# UNITED STATES PATENT AND TRADEMARK OFFICE

# Office Action Summary

10/590,913

TONNELIER, PIERRE

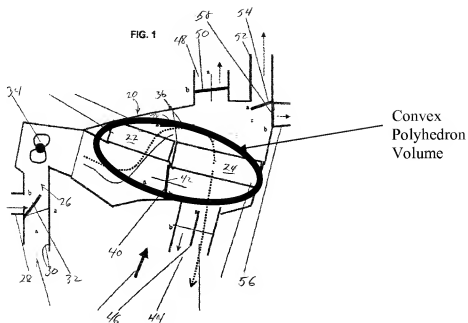
Alber et al teach said at least one first heat exchanging device (ref 22) and said at least one second heat exchanging device (ref 24) are both located within a volume defined by a convex polyhedron, said volume lying entirely inside said housing (ref 20) (See annotated Figure 1 below; Paragraph 35). In view of Alber et al's teachings, it would have been obvious to one of ordinary skill in the art at the time of invention to locate the two heat exchangers in the same area since it would allow for a reduced overall size of the housing, which would reduce the amount of material needed to create the constructional unit.

Alber et al teach said at least one first heat exchanging device (ref 22) and said at least one second heat exchanging device (ref 24) are both located within a volume defined by a convex polyhedron, said volume lying entirely inside said housing (ref 20) (See annotated Figure 1 above; Paragraph 35). In view of Alber et al's teachings, it would have been obvious to one of ordinary skill in the art at the time of invention to locate the two heat exchangers in the same area since it would allow for a reduced overall size of the housing, which would reduce the amount of material needed to create the constructional unit.
